ORIGINATION FORM

Proposed Revisions to a Standard Plans Index
(Please provide all information — Incomplete forms will be returned)

Index Number: 649-010
Sheet Number (s): 2 of 3
Index Title: STEEL STRAIN POLE

Sheet 2: Changed Note 1 and revised Section A-A to add clarity to anchor bolt nuts.

SECTION A-A

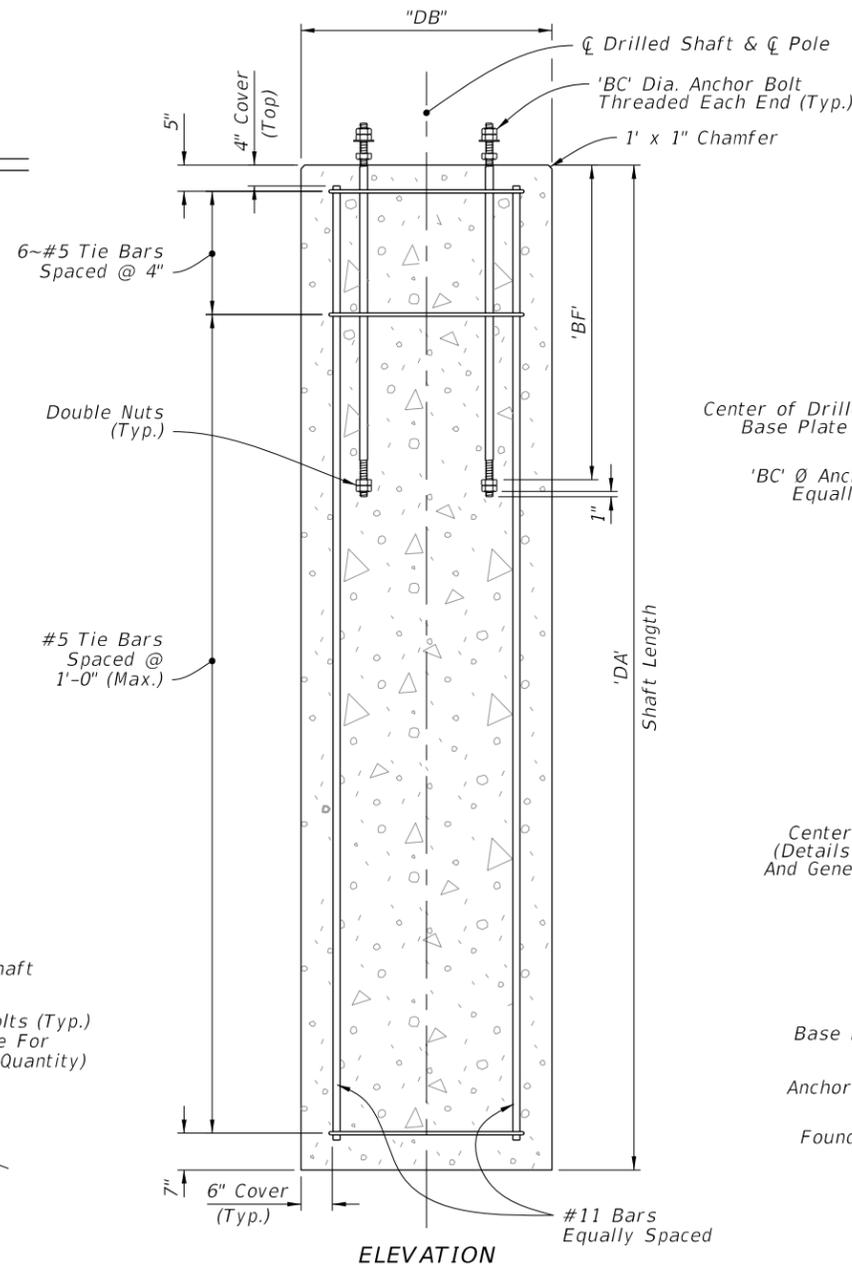
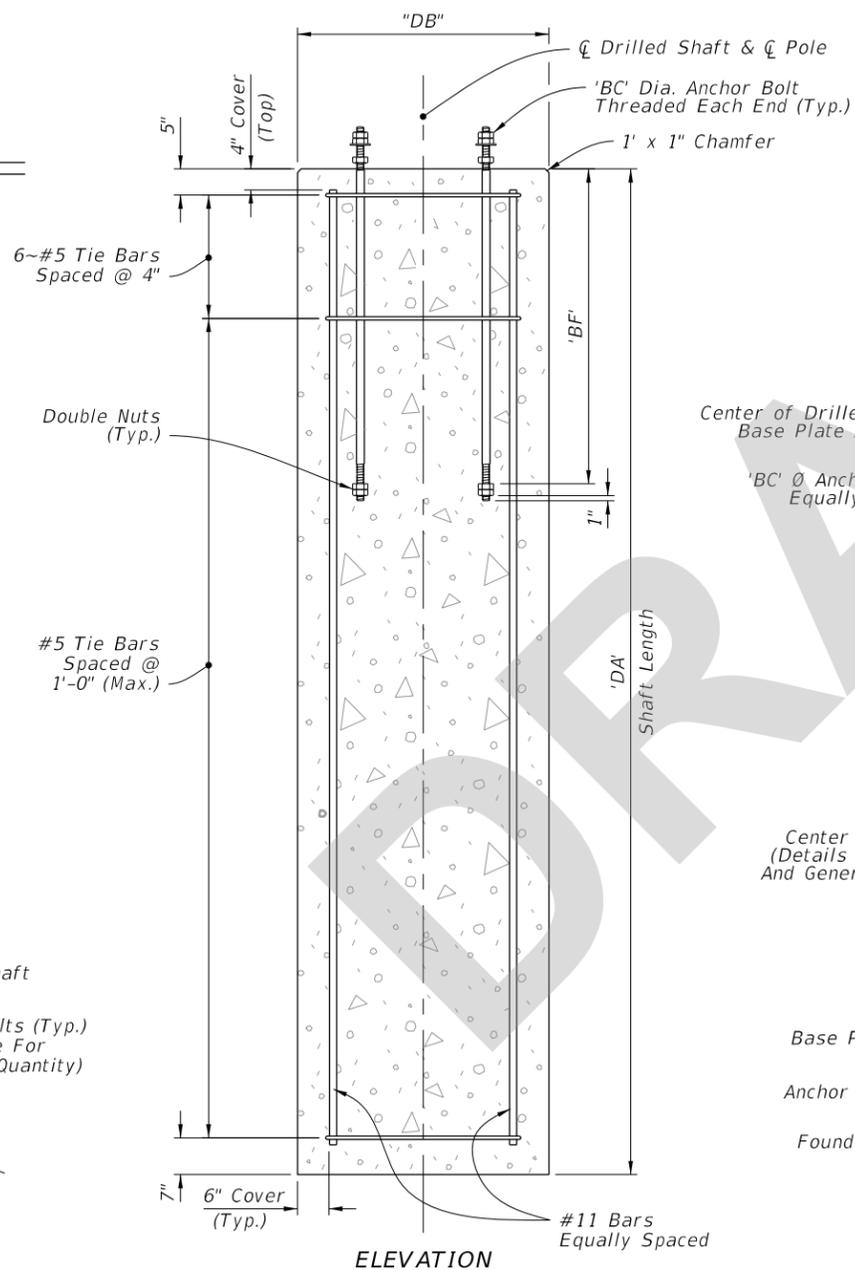
Sheet 2: These changes were to add clarity, consistency, and specificity to the anchor bolt nuts.

NOTE:
 1. ~~Double Nuts:~~ Bottom nut may be half-height ~~jam nut~~. Provide individual nut covers (not shown) for each bolt.

1. Retainer nut may be half-height. Provide individual nut covers (not shown) for each bolt.
